Service Information

To : ICOM Distributors
From : ICOM Inc. / CS Department
Ref No. : ZSM00010
Date : March 14, 2006

IC-7000 : Stop the AF 8 kHz Tone Noise

<IC-7000 LOGIC UNIT : TOP VIEW>

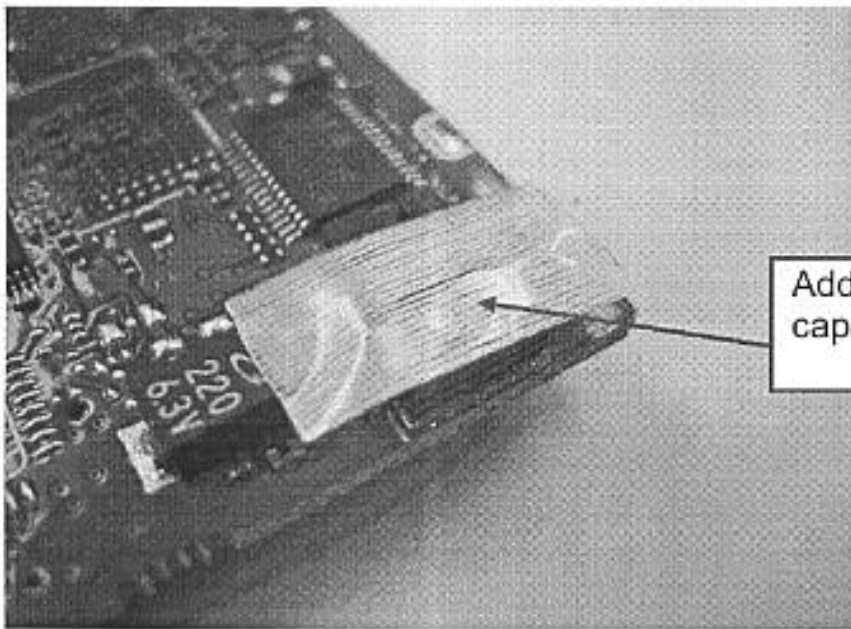
1. Model IC-7000
2. How to improve Change the location of capacitors
3. Replace parts Remove capacitors from LOGIC UNIT

Ref. NO.	Part NO.
C207	4030018960 C3216 JB 1C 106MT-N
C208	4550006780 TEESVB2 0J 476M8R
C209	4550006780 TEESVB2 0J 476M8R
C202	4550007310 F930 J227MNMBMA
(Replace)	Replace C202 form the bottom → top of the LOGIC UNIT

Remove the solder on the terminal to prevent short circuit between the LOGIC shield cover.

Add insulation tape on the tantalum capacitor.
